S E R V I C E   N O T E

J2301B Internet Advisor

Serial Numbers: J2301B-05-S: US35340000-US35359999 EC: Label #09

Bottom chassis fastener (screw) may interfere with primary circuit component.

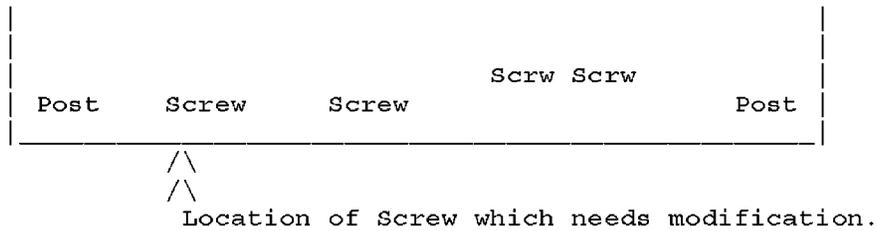
Situation:
Metal bottom chassis fastener to power supply may defeat the insulation on a primary circuit capacitor if long screw is used and cause the primary voltage to be present on the chassis.

1. Note the Location of the metal fastener along the rear bottom chassis, the diagram is shown with the instrument sitting on its back, handle up:

2. Remove the metal screw completely. Use tool T10 Torx Driver.

3. Install nylon screw (0515-1348) at the same location.

If nylon screw does not seat fully, the Analyzer power supply must be inspected for Capacitor damage. If component insulation or if the Capacitor location is touching the PEM, the power supply must be replaced.

It is highly recommended that the nylon screw be installed with a locking compound such as Locktite™, and the head of the nylon be cut off flush with the bottom chassis.

4. Affix the label next to the plastic fastener.
